**SUBJECT: GRAND GULF NUCLEAR STATION, UNIT 1 – ISSUANCE OF AMENDMENT NO. 223 TO REVISE TECHNICAL SPECIFICATION (TS) 3.3.1.1, "REACTOR PROTECTION SYSTEM (RPS) INSTRUMENTATION," AND TS 3.3.4.1, "END OF CYCLE RECIRCULATION PUMP TRIP (EOC-RPT) INSTRUMENTATION" (EPID L-2019-LLA-0007)**

SAFETY EVALUATION BY THE OFFICE OF NUCLEAR REACTOR REGULATION

RELATED TO AMENDMENT NO. 223 TO

GRAND GULF NUCLEAR STATION, UNIT 1

Figure 1: NRC Staff Margin Calculation

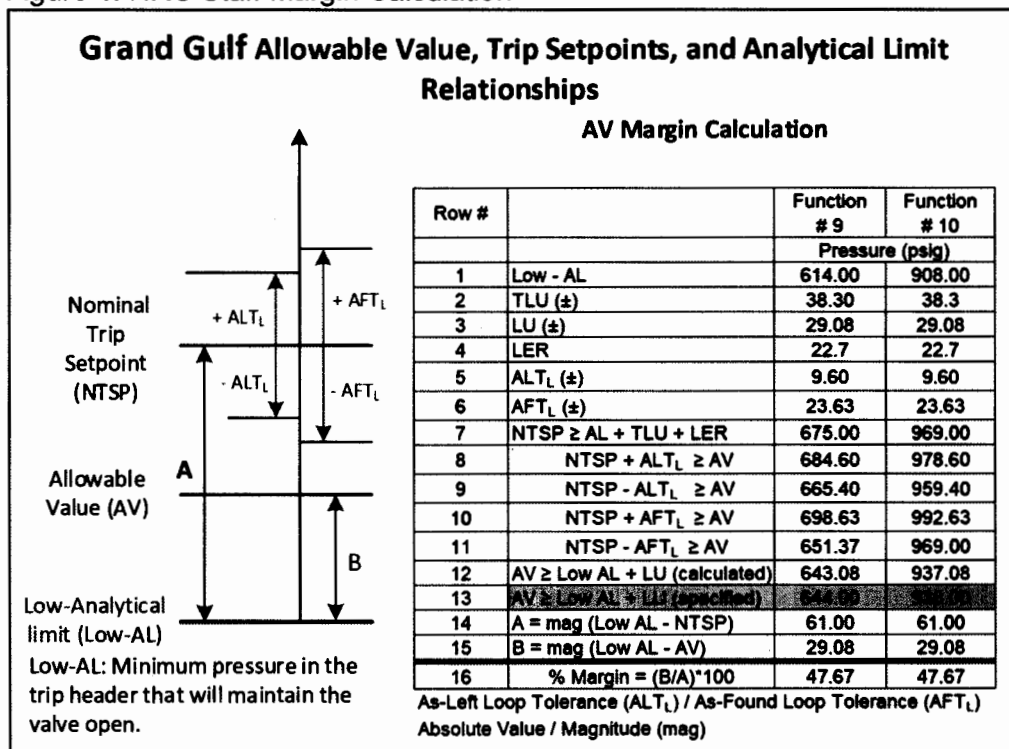
The licensee's results of the Grand Gulf transmitter uncertainty calculations are illustrated in Figure 1 below. The staff independently calculated the percent AV margins of Functions 9 and 10, and the results are shown on Rows 14 - 15 of the table "AV Margin Calculation" in Figure 1.

As indicated in Figure 1 above, the proposed NTSP with the as-left and as-found loop tolerance bands will be greater than the AV to ensure that the actual setpoints do not exceed the AV as the statement of the Grand Gulf Reactor Protection System Instrumentation bases. In addition, the NRC staff finds that the margin percent (as indicated in Figure 1 above) are adequate at a value of 47.67 percent. These margins reflect that the trip setpoints have been chosen to assure that a trip or safety actuation will occur automatically and significantly before the measured process reaches the Low-AL level. Thus, these proposed AVs for the TSV Closure, Trip Oil Pressure-Low and TCV Fast Closure, Trip Oil Pressure – Low functions are consistent with RG 1.105 and satisfy the requirements of 10 CFR 50.36(c)(1)(ii)(A) and GDC 13.

Based on the above evaluations, the NRC staff finds that the proposed revision of the Grand Gulf TSs regarding the AV for Function 9 (TSV Closure, Trip Oil Pressure – Low) and Function 10 (TCV Fast Closure, Trip Oil Pressure – Low) is acceptable because, the methodology, analysis and assumptions used in this application are consistent with the regulatory requirements and the conditions identified in Section 2.3 of this SE.
